Subject: **Docket Nos. 50-361 and 50-362**
Proposed Change Number NPF-10/15-508
Control Element Assembly Reactivity Worth Test Methodology
San Onofre Nuclear Generating Station, Units 2 and 3

Evaluation For Proposed Modification to
Low Power Physics Test Program

Figure 1
 Example of Odd Cycle CEA Group Measurements
 Core Locations of CEA Groups 6, 5, 4, 3, 2, and B

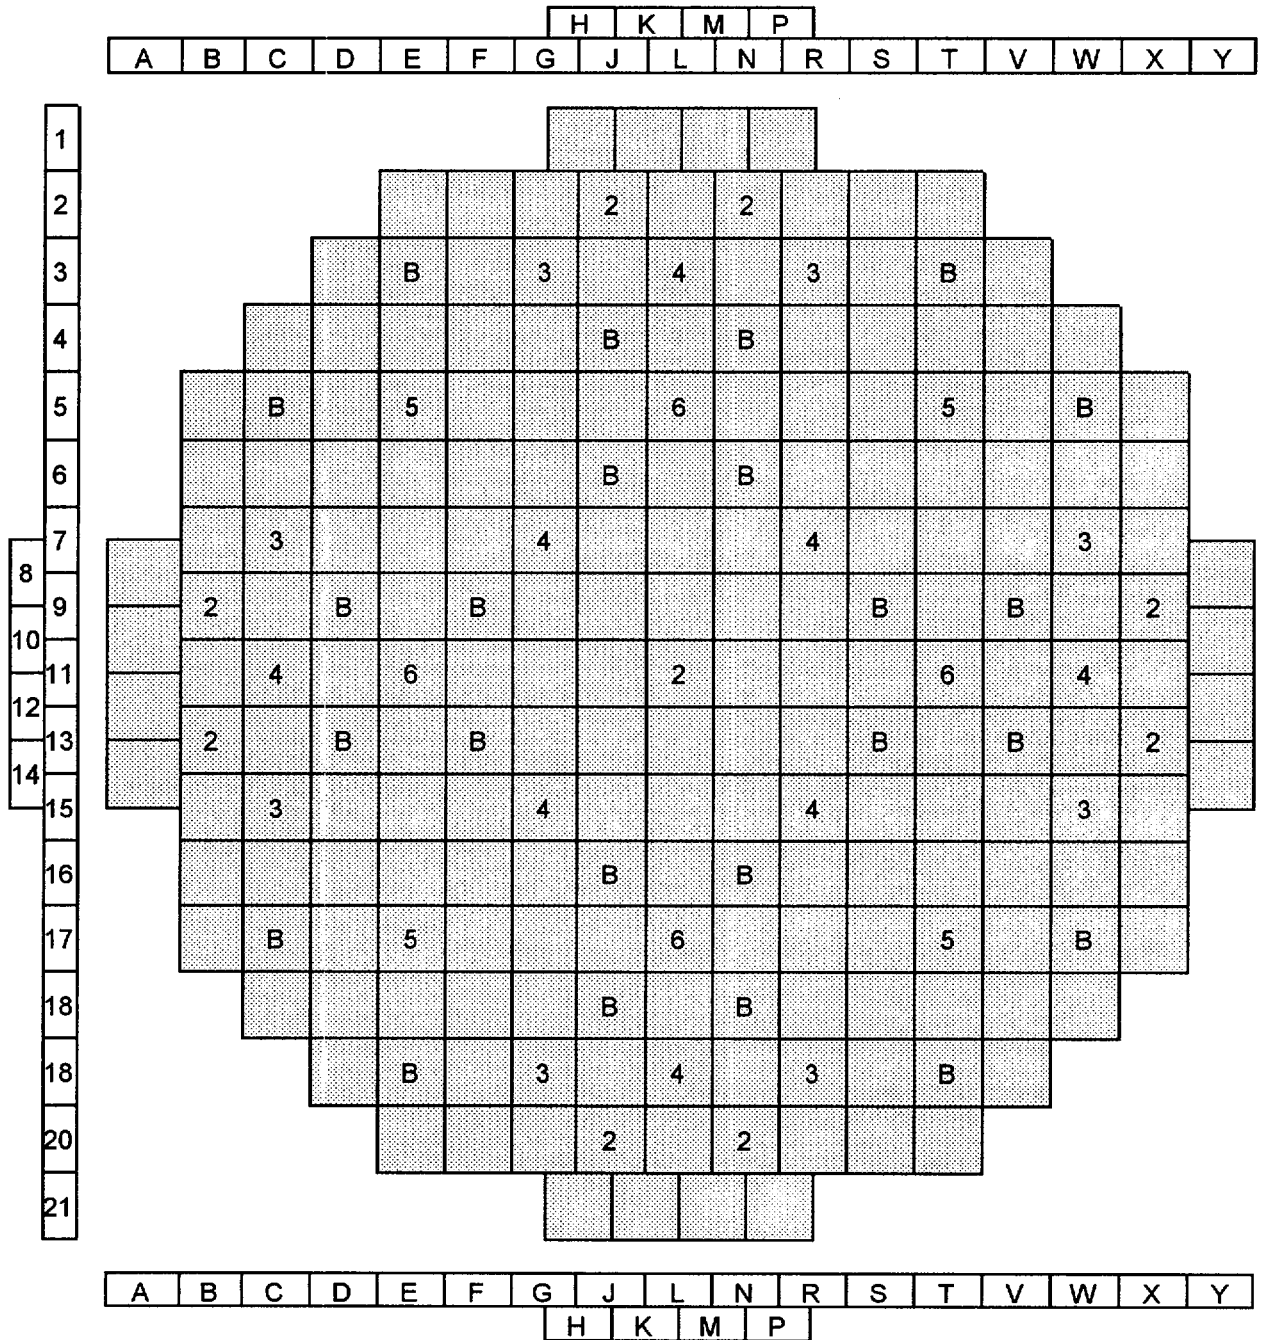
Figures 1 and 2 show a possible selection of CEA groups to be tested using the proposed strategy. In this example, Regulating CEA Groups 6, 5, 4, 3, & 2 and Shutdown Bank B would be measured in "odd" cycles, and Regulating CEA Groups 6, 5, 4, 3, & 1 and Shutdown Bank A would be measured in "even" cycles. Thus, Regulating CEA Groups 6, 5, 4, and 3 would be measured each cycle; CEA Group pairs 2 & B and 1 & A would each be measured only in alternate cycles.
